RE: **Lot 10 Block 4 Unit 18, S.A.D. 228**
Volcano Cliffs Subdivision
6611 Cuervo Pl. NW
Grading and Drainage Plan D10D003J10
Engineers Stamp Date 12/13/2021

Based upon the information provided in your submittal received 12/14/2021, this plan is approved for Grading Permit. **Dirt is not allowed to climb the curb, use crusher fines or lumber for this purpose.**

CANDELARIA HOMES (ADAN) - G & D PLAN

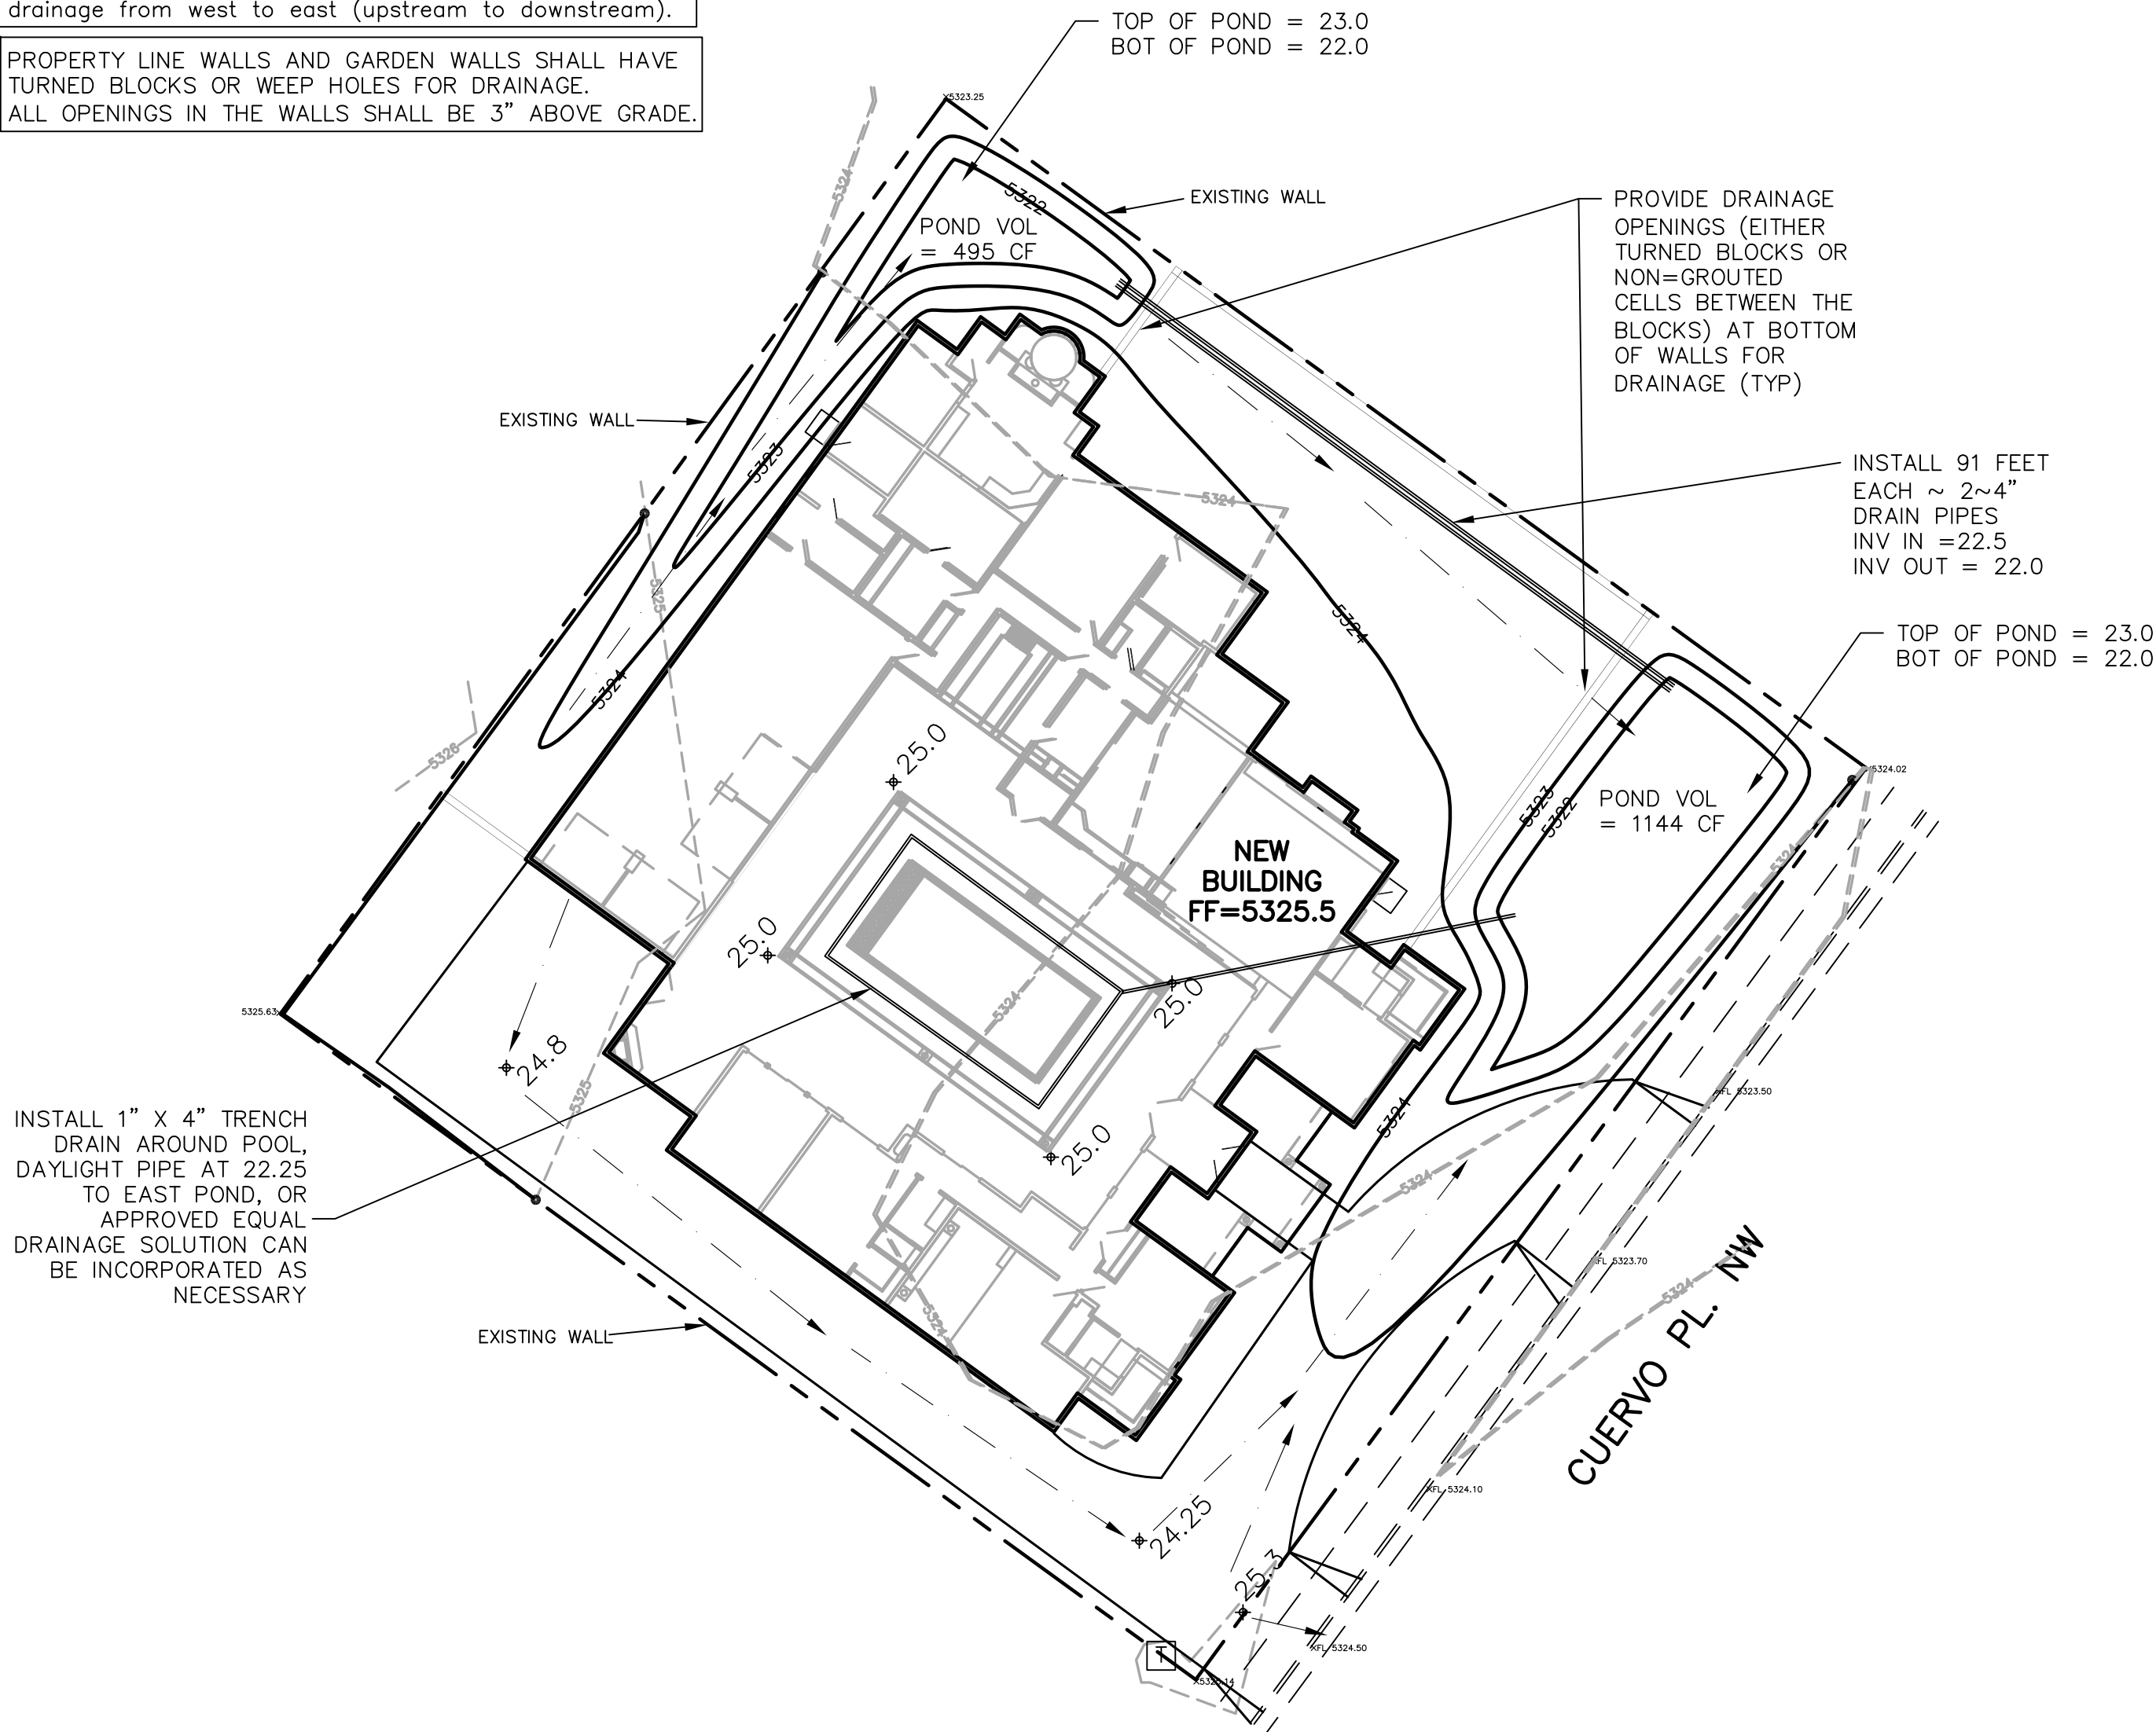
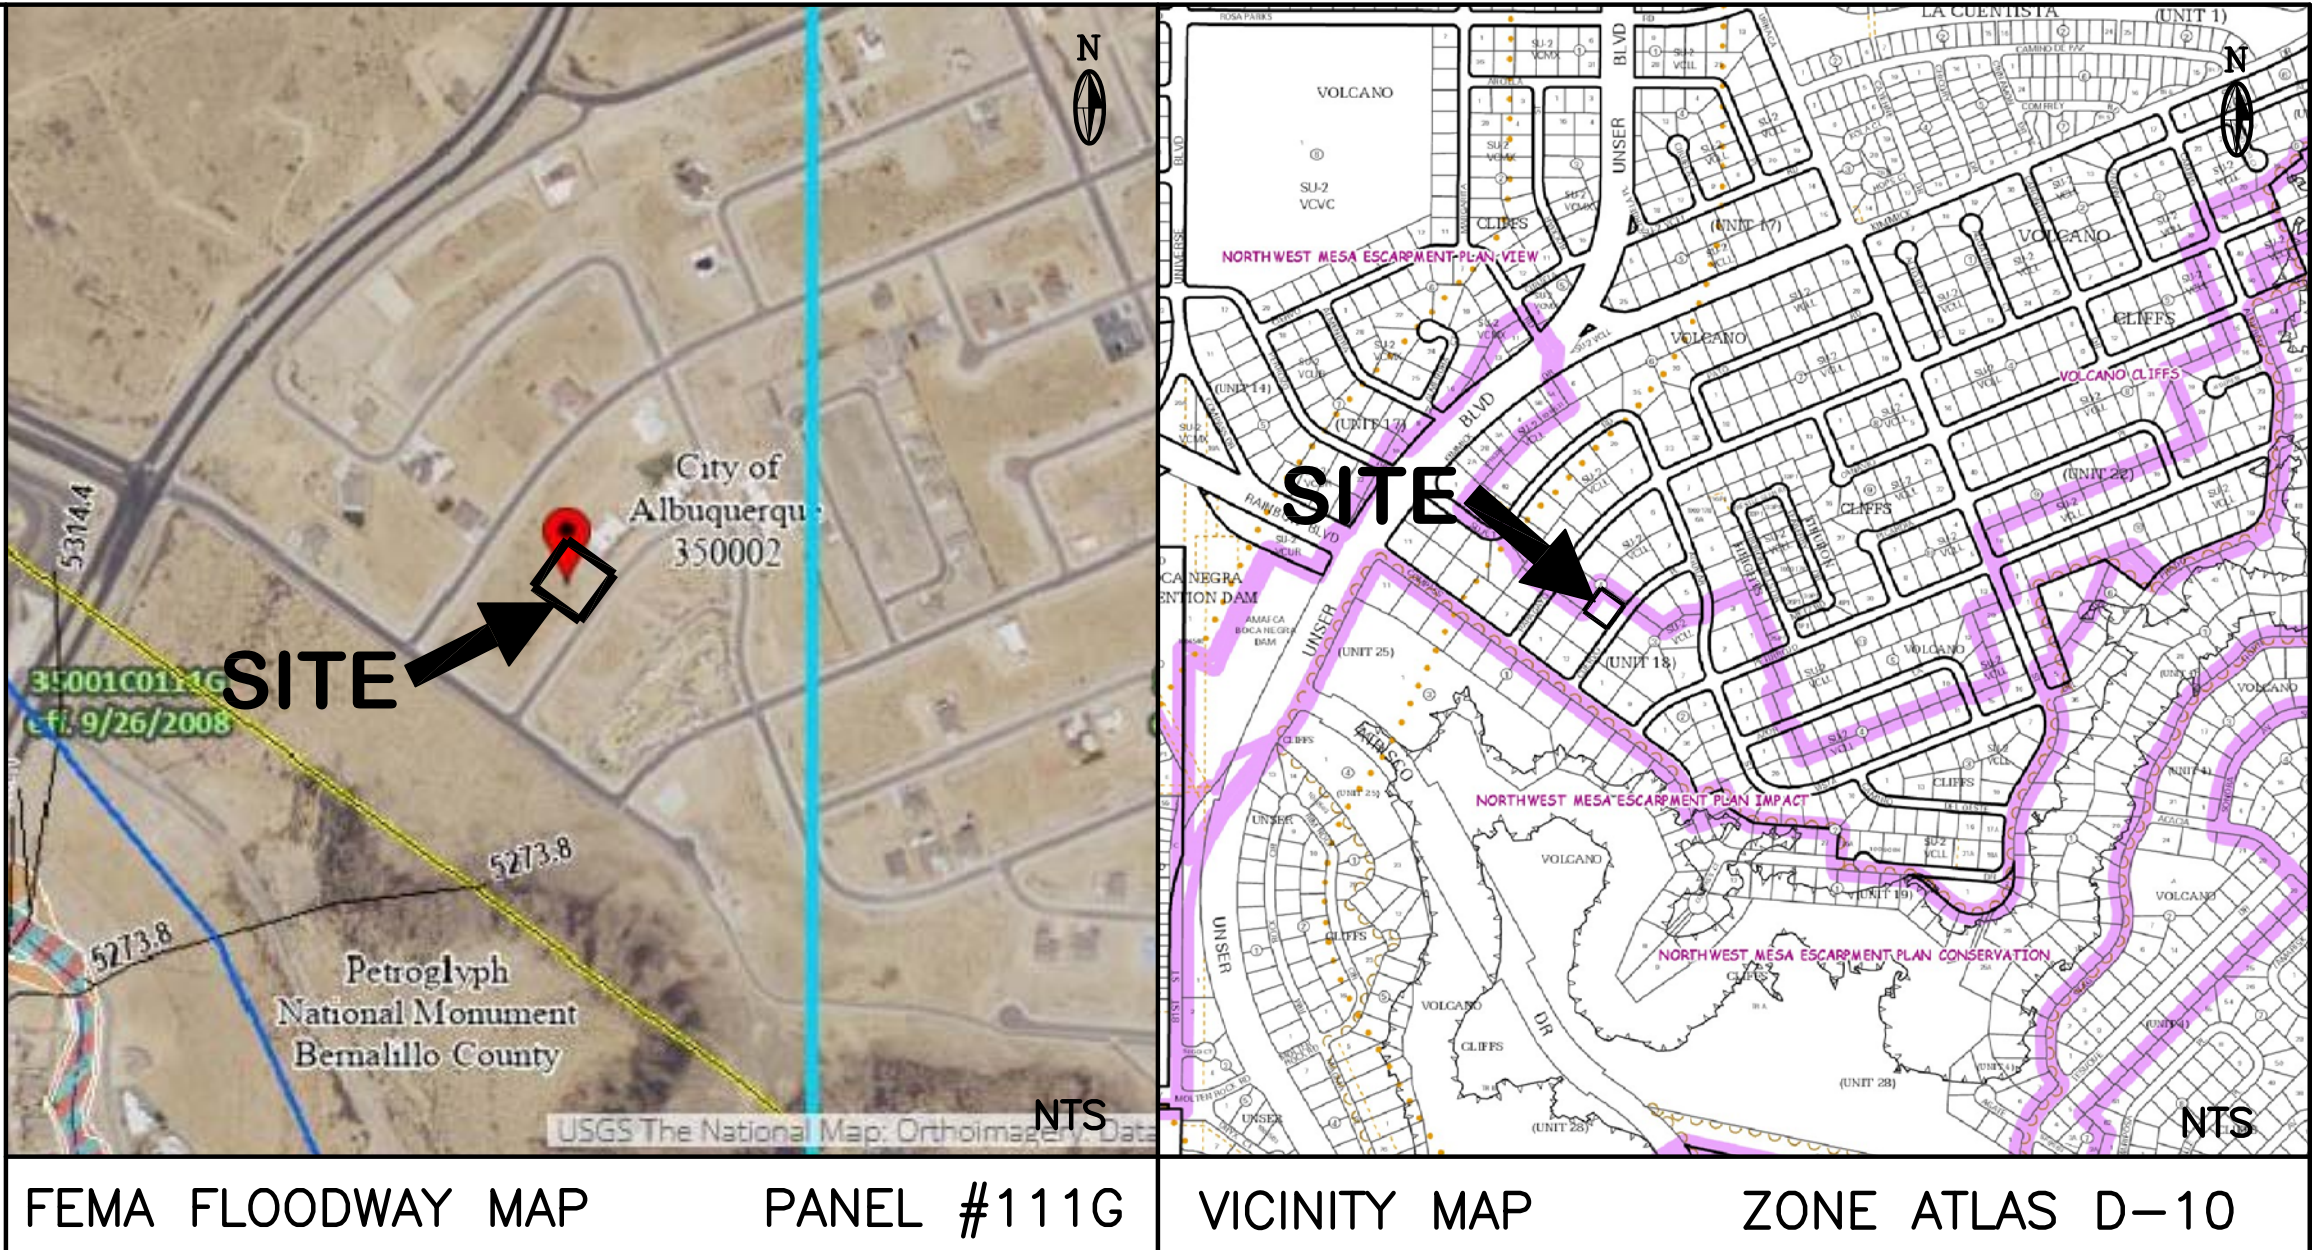
Prior to Building permit approval a Pad Certification will be required, provided by the Engineer or a registered Land Surveyor.

Reiterate to the Owner/Contractor that a separate permit for a garden/retaining wall must be obtained, with the approved G&D plan.

Prior to Certificate of Occupancy release, Engineer Certification per the DPM checklist of this plan will be required.

This is the plan to be used for any garden walls and any openings in the walls shall be placed 3" above final grade in the rear yard to allow for cross lot drainage from west to east (upstream to downstream).
